Addendum Report - Outer Suburbs

WCC Spatial Plan - Three Waters Assessment

March 2020

Outer Suburbs Adjusted Growth Scenario

Figure 1: Churton Park growth scenario and cost band breakdown

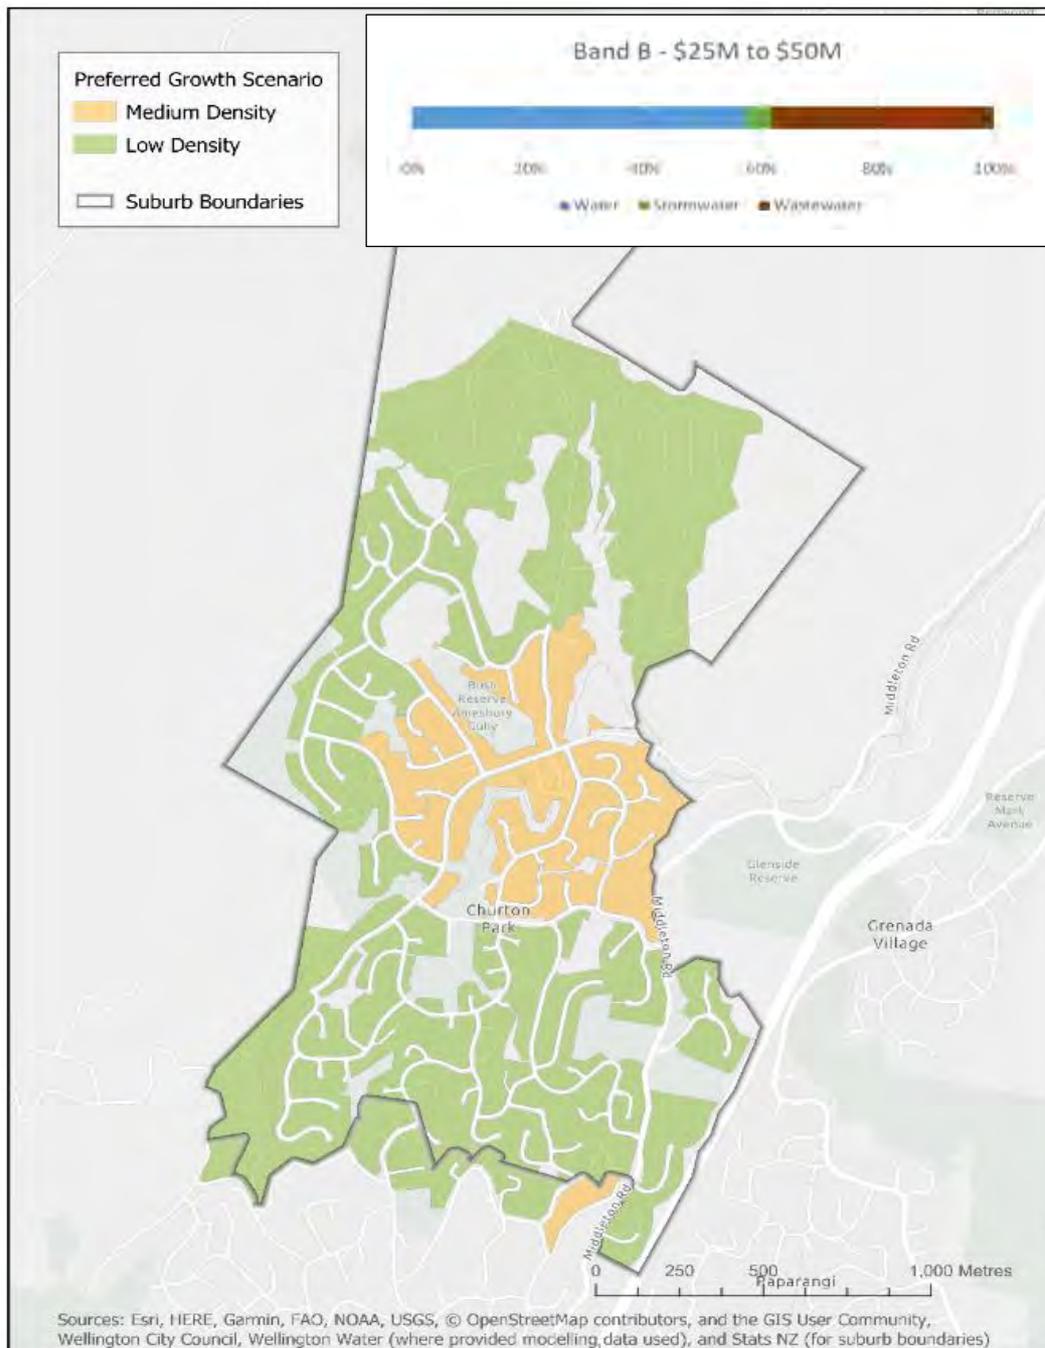
The growth scenario and associated cost band for Churton Park is represented in Figure 1 below.

Existing Constraints	Needed Infrastructure
Water	System performance issues with a predicted pressure drop below 25m for around 30 customers in the Lakewood Avenue and Mallard Grove. There is a current shortfall in storage. A few properties with low water pressure	Potential 2 ML of water supply storage to address the shortfall and a likely upgrade of the existing water supply mains to increase capacity in the system
Wastewater	The aging network and increased wet weather overflows	0.4 ML storage of wastewater required to minimise wet weather overflows. There is a likely upgrade of the gravity trunk main that is currently under capacity.
Stormwater	There are no significant flooding impacts in Churton Park, however, increased impermeable surfaces in this area may cause downstream effects to Tawa – which has known potential for flooding.	New developments would be expected to meet hydraulic neutrality to ensure that flooding impacts do not occur in the downstream sections of the catchment especially at Tawa. Onsite stormwater neutrality is assumed at developers cost. No other major infrastructure upgrades are anticipated at this time. There are potential benefits to retrofitting and installing water sensitive devices around the existing town centre to treat stormwater runoff using devices, for example, rain gardens.

Figure 3 Miramar growth scenario and cost band breakdown

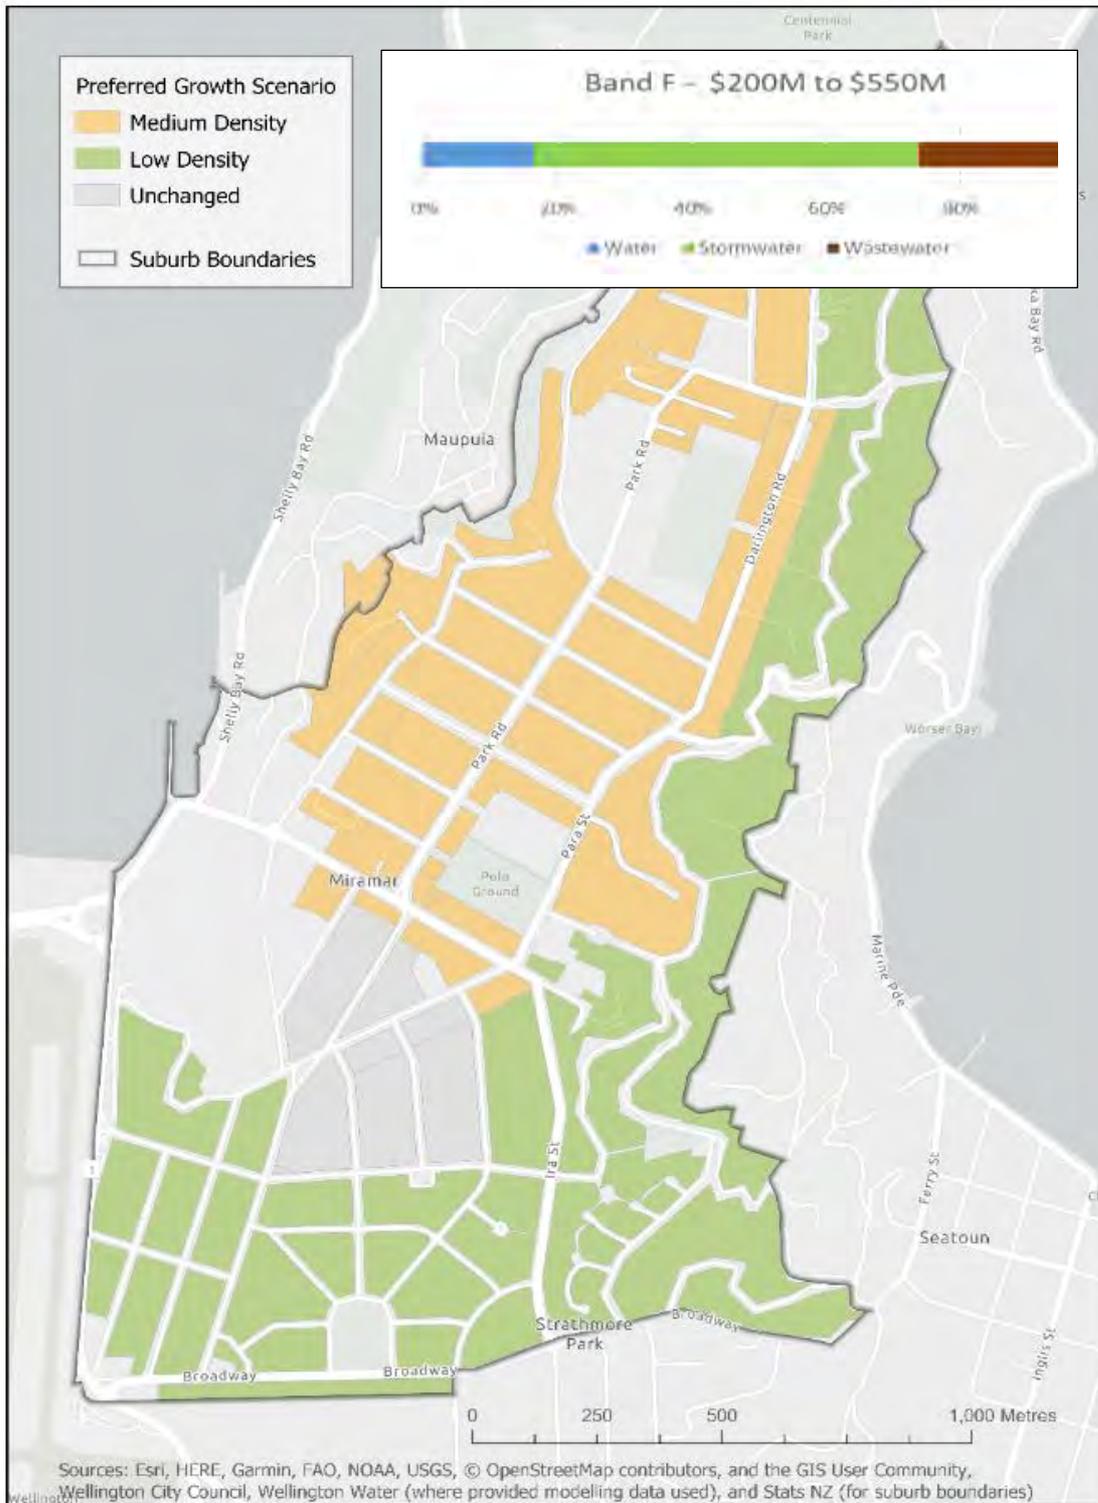
The growth scenario and associated cost band for Miramar is represented in Figure 3 below.

Existing Constraints	Needed Infrastructure
Water	System performance issues with a predicted pressure drop for a few properties. There is a current shortfall in storage.	To accommodate projected growth in Kilbirnie, Miramar, Lyall Bay and Hataitai around 13.5 ML of additional storage is required. Approximately 10 ML of this is to cover existing shortfall. Mains upgrade is estimated at 0.7 km to 300mm diameter. 0.7 km of 300mm diameter mains upgrade and 13.5 ML of storage.
Wastewater	The aging network and increased wet weather overflows. Wastewater pipes are under capacity and prone to high I&I. A new pump station with rising main and also gravity mains is required to service the relocated growth area. 4.3 km of poor condition pipe upgrades for water quality and 3.6 km of mains upgrade for capacity.	Approximately 8 km of existing pipe upgrades and replacement. In addition 1 km of 250 mm diameter PE rising main and 2 km of 375 mm diameter concrete pipes as gravity main is required. A new pump station with 110 l/sec capacity is also required to service the relocated growth area.

Stormwater	Existing Miramar town centre area is prone to flooding and any upstream intensification will lead to additional flood flows exacerbating flooding. It is estimated that 2.6km of stormwater pipe upgrades would be required. Flooding can also be exacerbated due to sea level rise.	2.6 km of stormwater pipe upgrades in addition to stormwater treatment devices. To address sea level rise a large pumpstation up to 40 m ³ /s capacity with associated outlet pipe upgrades. Stormwater runoff treatment from medium and high intensity development areas using rains gardens. New developments would be expected to meet hydraulic neutrality to ensure that flooding impacts do not occur in the downstream sections of the catchment. Onsite stormwater neutrality is assumed at developers cost. No other major infrastructure upgrades are anticipated at this time. There are potential benefits to retrofitting and installing water sensitive devices around the existing town centre to treat stormwater runoff using devices, for example, rain gardens.
